Model: T-Series Top Drives

Product Bulletin # TDS-258 Rev 1

Grabber Clamping Box Inspection

Figure 2: Grabber clamping box

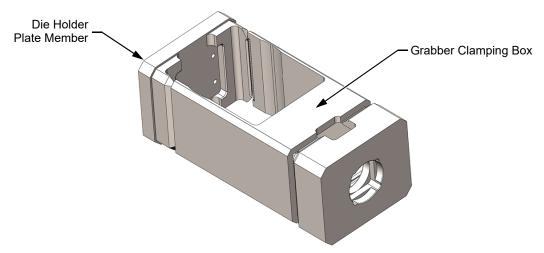
Canrig recommends inspecting the grabber clamping box including welds and replace the part if cracks or signs of damages are present.

Figure 3: Grabber die plate inside corners

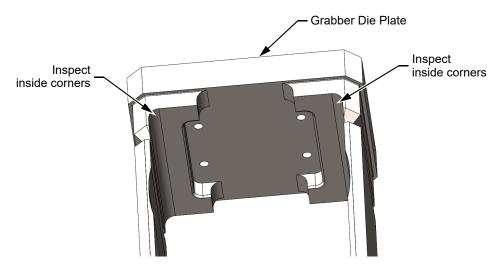
1. Visually check the entire grabber clamping box including the inside corners of the grabber die plate for cracks or other signs of damage.

- 2. Perform MPI on the parts when downtime schedule permits.
- 3. Replace all grabber clamping boxes immediately if cracks or signs of damages are present.
